**Marbach Pump Station Improvements (Volume I) &
Mission Road Service Center Drainage (Volume II) (RFCSP)
Solicitation Number: CO-00533
Job No(s): 20-6001/21-2501**

**ADDENDUM 6
September 27, 2023**

**SCADA AND SECURITY
NETWORK BLOCK DIAGRAM**

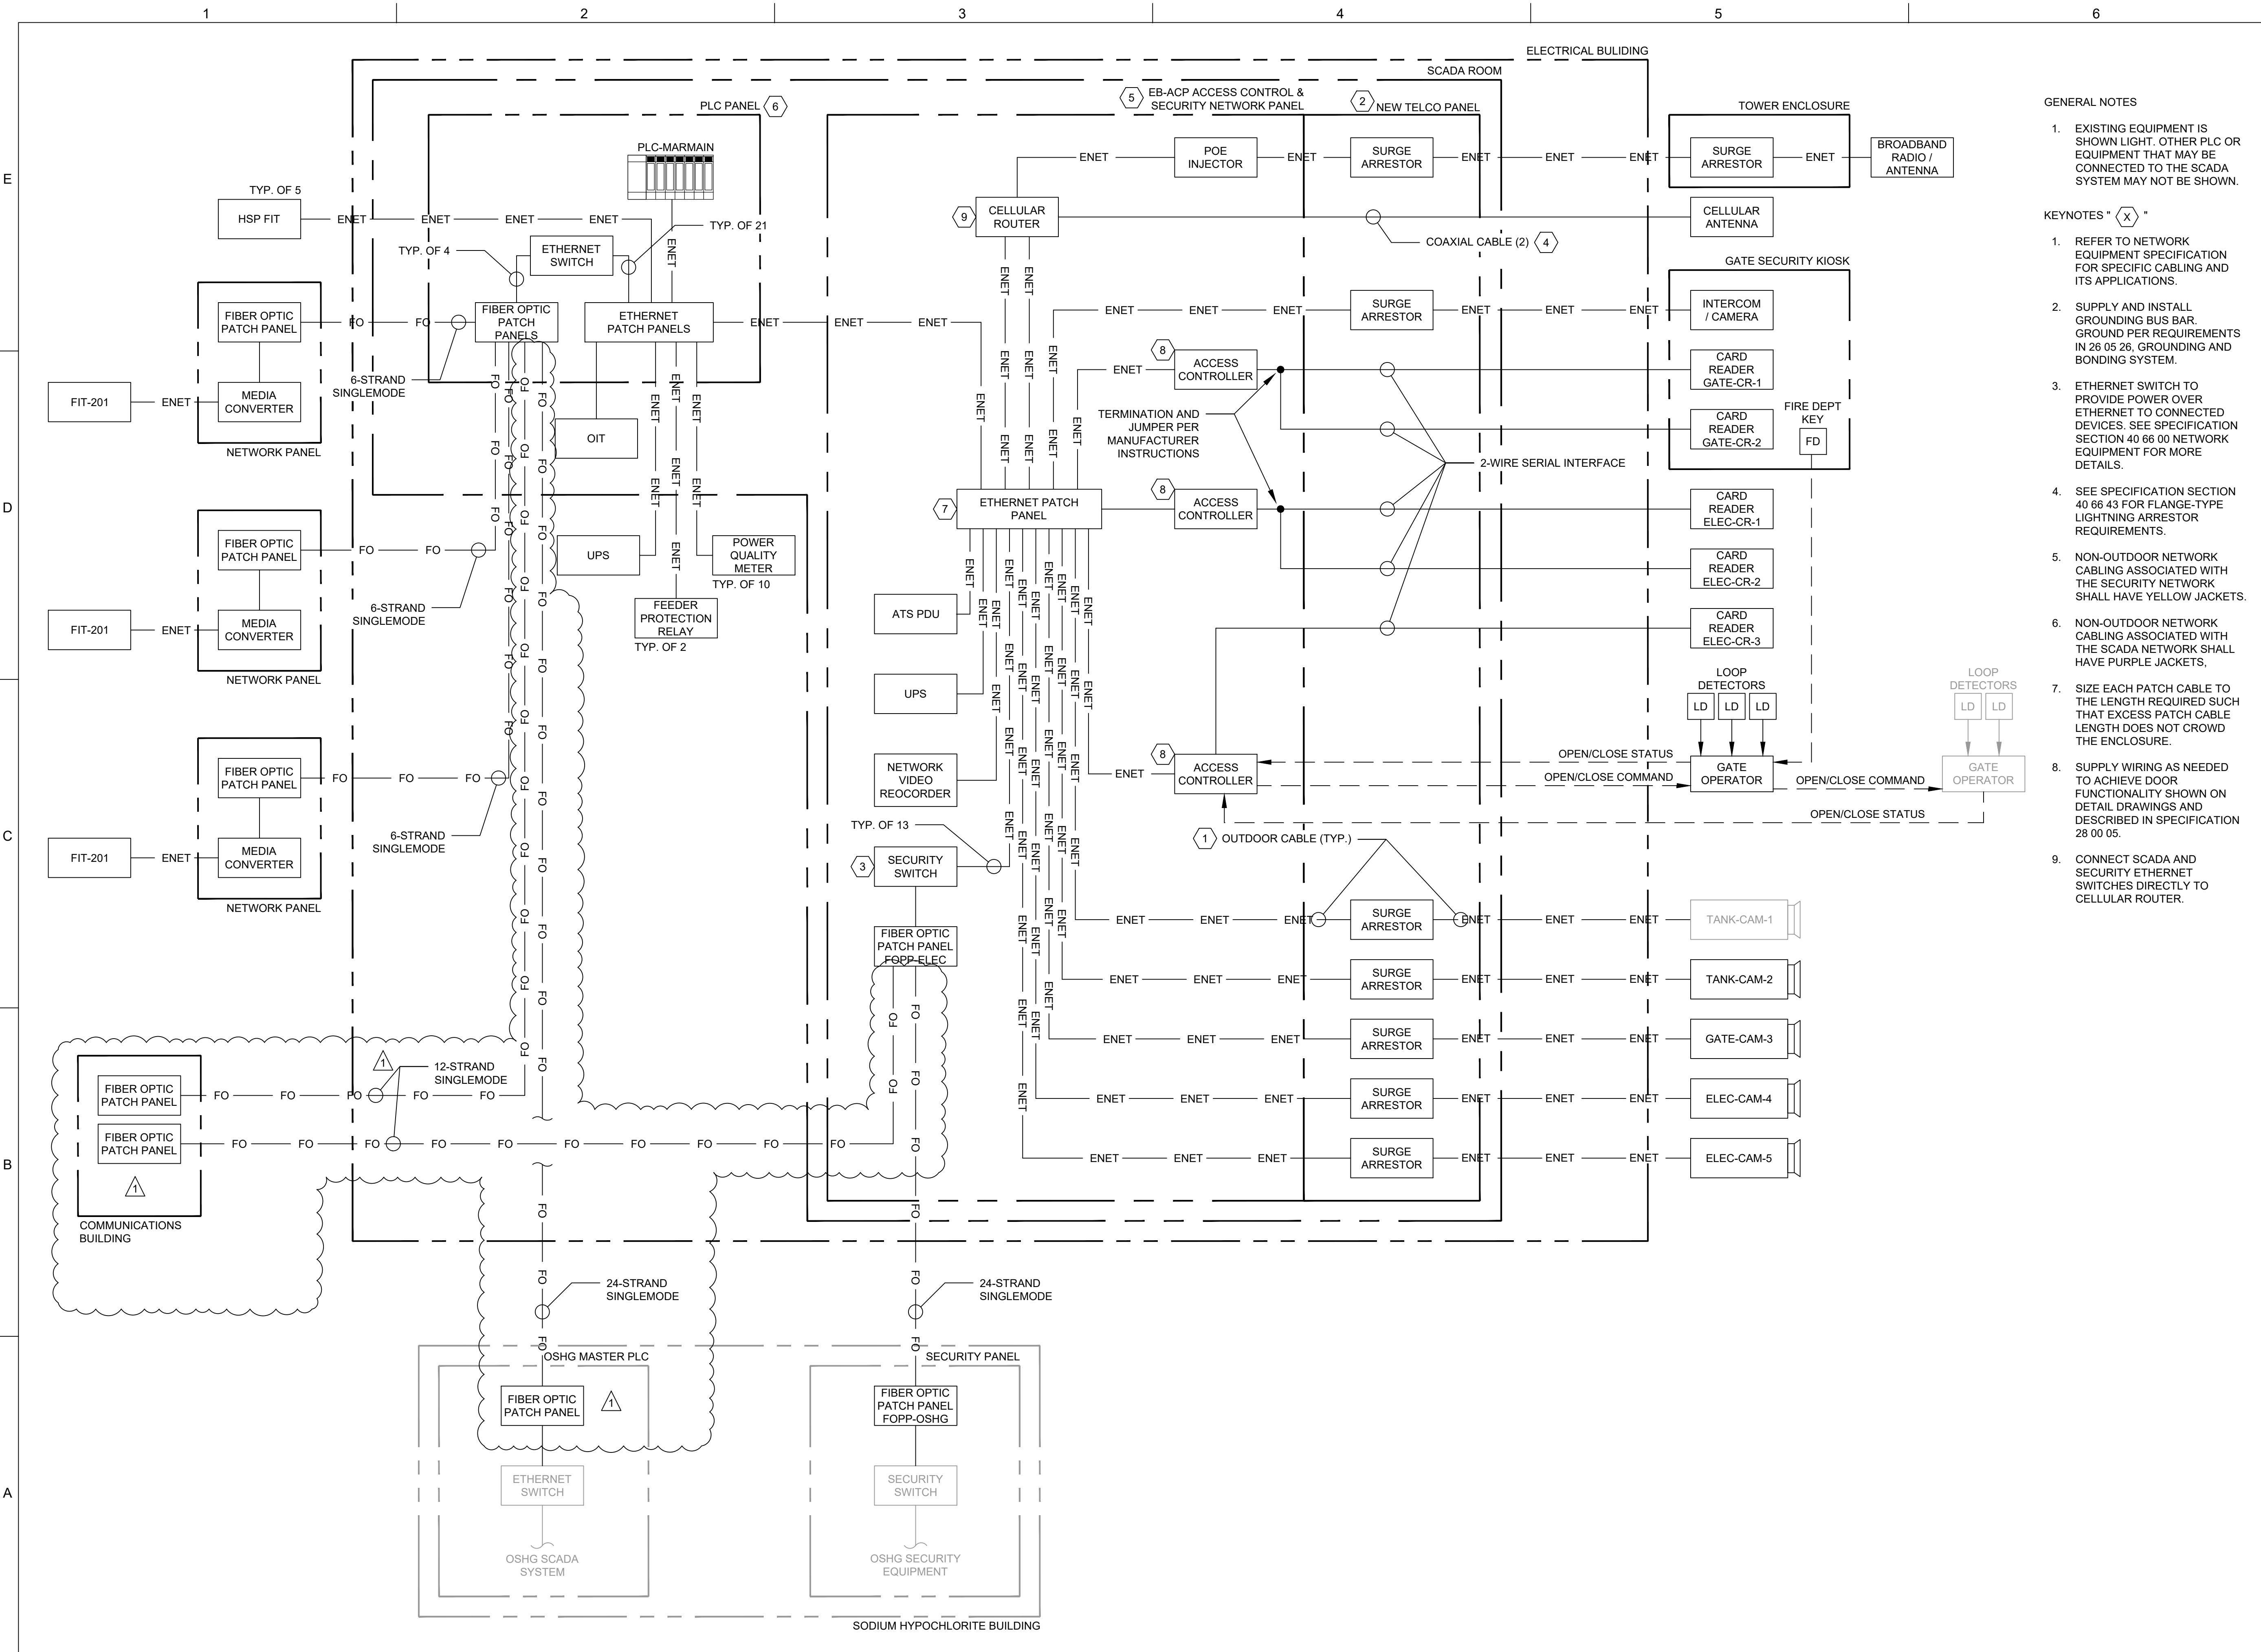
- 81. Question: On Drawings I-03 and IS-01, It shows the Fiber runs from the Electrical Building SCADA panel to the (3) Well Network Panels to be 6-strand. Fiber Spec 40 66 33-1 1.1.A.2 claims these to be 12-strand runs. Please clarify.**

- 82. Question: Referencing the same spec, Cable ID I-03-01 ‘Security’ Fiber run is shown on DWG IS-01 as separate from the EB PLC to OSHG Master PLC run, while DWG I-03 shows just the one run from EB Control Room to OSHG FOPP. The EB PLC to OSHG PLC run is not listed in the table, but I assume that needs to be accounted for as well? Please advise.**
